March 27, 2006
LIC-06-0023

SUBJECT: Response to Requests for Additional Information and Revision of Fort Calhoun Station Unit No. 1 License Amendment Request, "Criticality Control During Spent Fuel Cask Loading in the Spent Fuel Pool"

Attachment 1
Omaha Public Power District (OPPD) Response to NRC's Request for Additional
Information (RAI) on Fort Calhoun Station, Unit No. 1
License Amendment Request (LAR)
"Criticality Control During Spent Fuel Cask Loading in the Spent Fuel Pool"

Figure 6-1

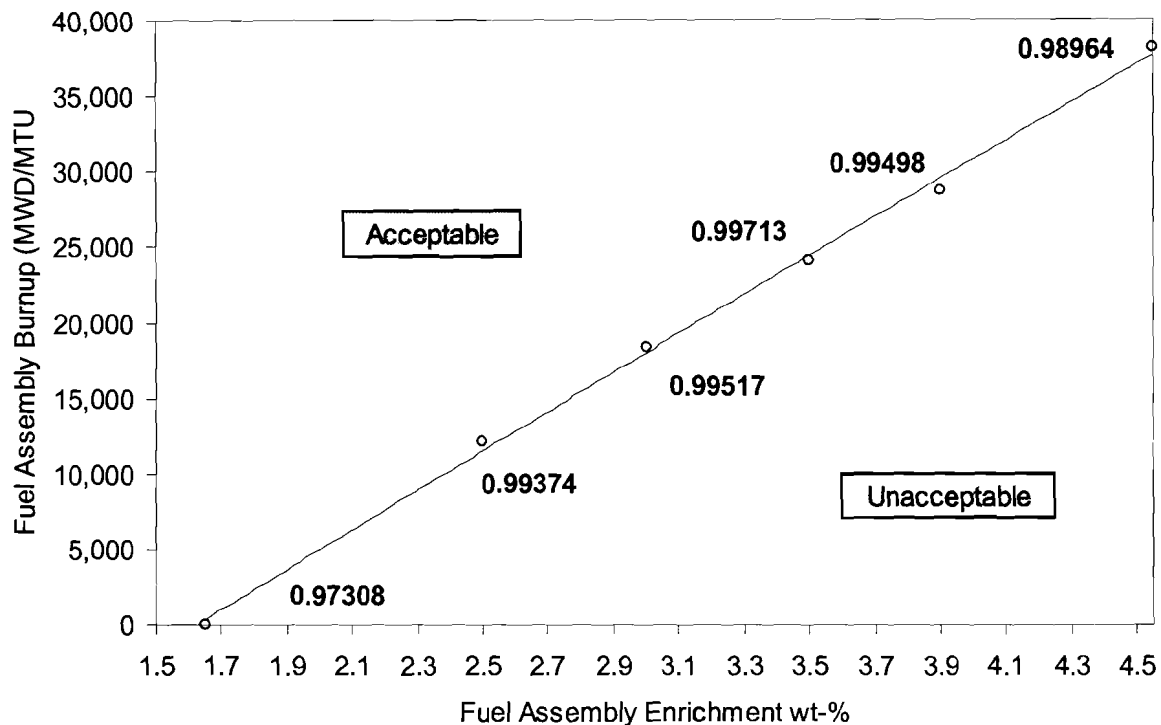
Clarify the discrepancy between Summary bullet 1 and page 21 of 36.

The correction above warranted further review of the report and a typographical error was found in the Table 6-1. Namely, the KENO $k_{eff}+2\sigma$ results for the 4.55 w/o U-235 case contained a typographical error which is corrected below. The correction is also applied to Figure 6-1.

The criticality analysis, Page 21 of 36, enclosed with LIC-05-0119 provided the cask assembly for a case with 500 ppm of soluble boron. The k_{eff} value listed did not include the 0.013 Δk_{eff} . This inadvertent omission is corrected below and the results continue to demonstrate the cask assembly k_{eff} is below 0.95.

The first bullet of the summary has been changed to reflect the correction discussed above and is now consistent Table 6-1:

- The most reactive DSC cask configuration (normal case) has a $k_{eff} < 1$ (i.e., 0.99713) with unborated water and a $k_{eff} < 0.95$ (i.e., 0.92073) when flooded with borated water at a concentration of 500 ppm. Both cases apply burnup credit.

Figure 6-2
DSC and Transfer Cask Position in the SFP Cavity^[8,10]

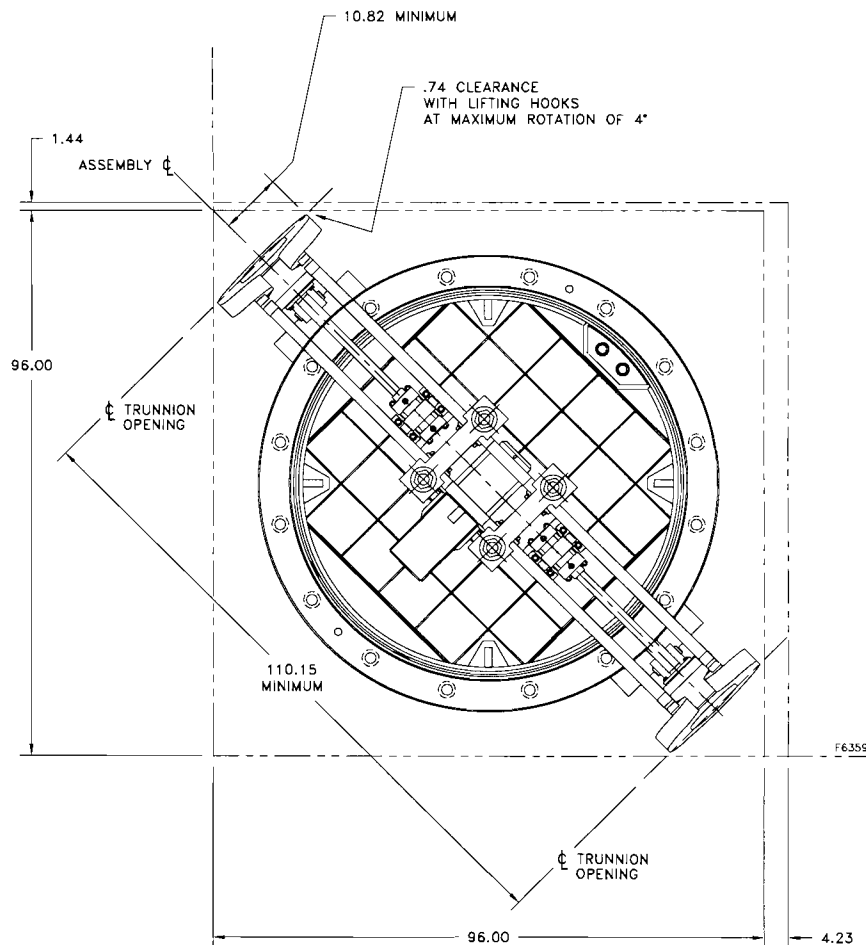
The DSC position in the spent fuel cavity is described as being 3 inches from the spent fuel racks. Later in the application, the location is described as being 3 centimeters. State the correct spacing between the fuel racks and the cask and whether the model was conservative in accounting for neutron coupling in the criticality analysis.

In the first paragraph of the License Amendment Request, Reference 3, section 4.1.3.6, Dry Shielded Canister, DSC, Position in the Spent Fuel Pool, SFP, Cavity, (page 12 of Attachment 1 to Reference 2) the unit of "inches" was incorrectly used. The fourth sentence should read, "In this orientation, the closest the transfer cask can approach the spent fuel racks is approximately three centimeters." The dimension of three centimeters is consistent with the dimension provided in section 6.5, DSC Position in the SFP Cavity, on page 23 of 36 of Enclosure 1 of Reference 2 and is the more conservative distance, i.e., the shortest distance, for neutron coupling.
